10 Year Health Life Safety Report

French Academy
520 West Wood Street
Decatur, IL 62522

Decatur Public School District #61
Decatur, Illinois
Macon County

APPLICATION FOR APPROVAL OF TEN-YEAR SAFETY SURVEY REPORT

1 BASEMENT FLOOR PLAN
1/32" = 1'-0"

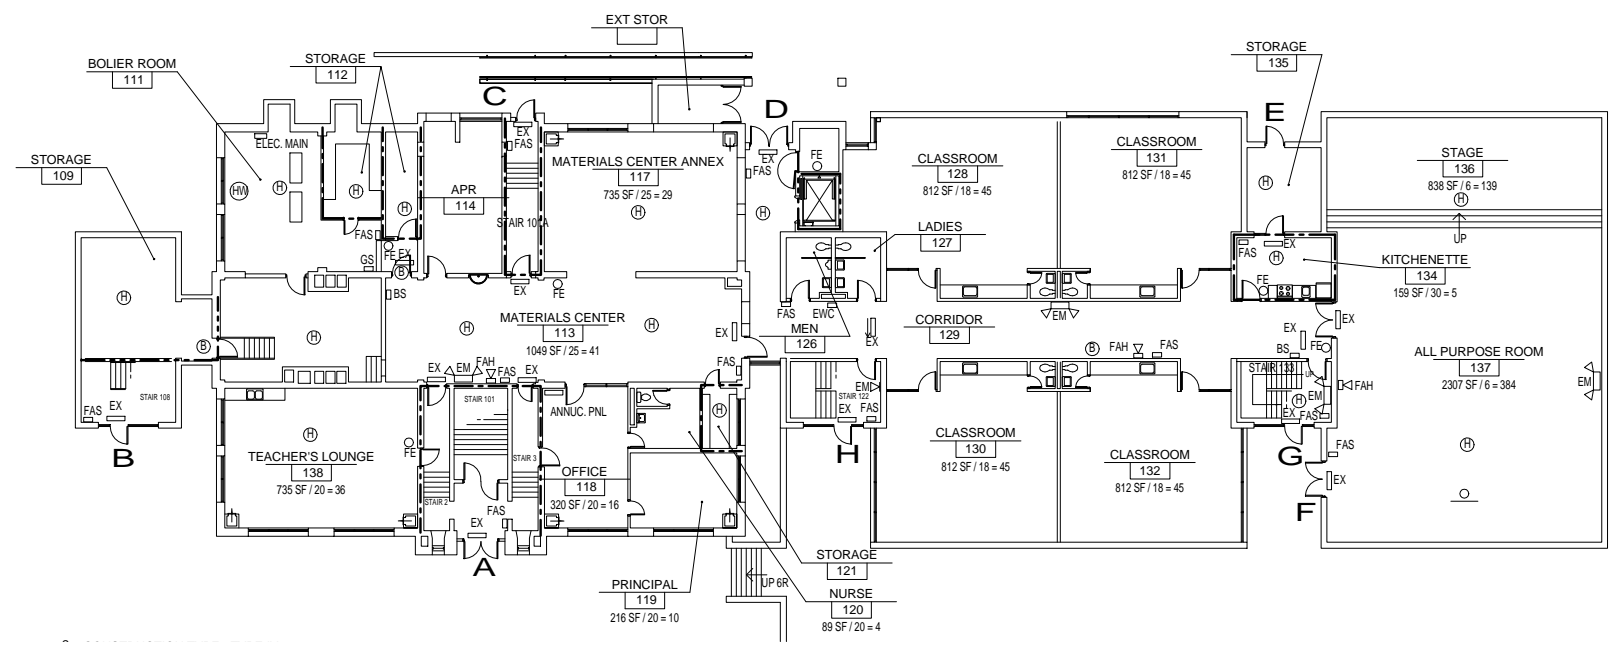
1. COUNTY CODE 055, Macon		2. DISTRICT CODE/NAME 0610, Decatur SD 61			3. FACILITY CODE/NAME MARY W FRENCH ACADEMY	
4. Item ID	5. Location(s) (Room No)	6. Priority Code	7. Rule Violated	8. Description of the violation	9. Recommendation to correct violation	
1	Science Lab	a.	175.285	Door does not close / out of alignment with frame	Adjust door and hardware to re-align door within frame	
2	Science Lab	a.	29 CFR 1910.151C	Access to emergency shower blocked by shelving unit	Remove shelving unit	
3	Science Lab	a.	29 CFR 1910.151C	Tools stored in emergency shower	Remove tools	
4	206, 207, 211, 212, 213	a.	PM 305.1	Carpet has deteriorated / lived beyond its useful life. Carpet has holes and is unravelling in multiple locations, creating a trip hazard.	Replace carpet	
5	Boiler	a.	IFC 315.2.3	Combustible storage inside boiler room	Remove combustible storage	
6	Boiler	a.	185.370.m.7.B	Storage room door at top of steps with 90 minute rating is propped open; storage is overflowing into boiler room	Remove / discontinue use of manual door stop

7	Boiler	a.	185.440.b.2	"Emergency Fuel Burner" switch not labeled adjacent to entry door	Label as Emergency Fuel Burner Switch	
8	Stair 201	a.	PM 305.1	Stair treads and risers have deteriorated / lived beyond their useful life. Treads and risers are cracked, broken, and missing pieces in multiple locations.	Replace stair treads and risers.	
9	Stair 1	a.	185.370.a.6.C	No emergency light is at the main entry stairs	Install additional emergency light in center exit landing	
10	Corridors 211, 210, elev. corr.	a.	185.370.a.6.C	No emergency lights are present on the second and third main corridors (1914 bldg)	Install emergency lights at center corridor Speech/Music south wall	
11	Stair 6	a.	185.370.a.6.C	No emergency light is in stairs for exiting	Install emergency light at landing	
12	Corridor 315A	a.	175.610.b	Outlets within 6 feet of a sink need to be GFCI per National Electric Code	Replace existing outlet with GFCI outlet

13	Janitor closets 304, storage 109	b.	185.510.a	Light fixture missing protective lens, broken lamps could be potential hazard for fire	Install lens on light fixture	
14	Classroom Closets 10, 9, 12, 7, 13, 17, 16, 20	b.	185.510.a	Light fixture missing protective lens, broken lamps could be potential hazard for fire	Install lens on light fixture or replace light fixtures 2/classroom	
15	Facility	b.	185.510.b	Existing fire alarm system worn beyond its useful life	Replace fire alarm system and update system
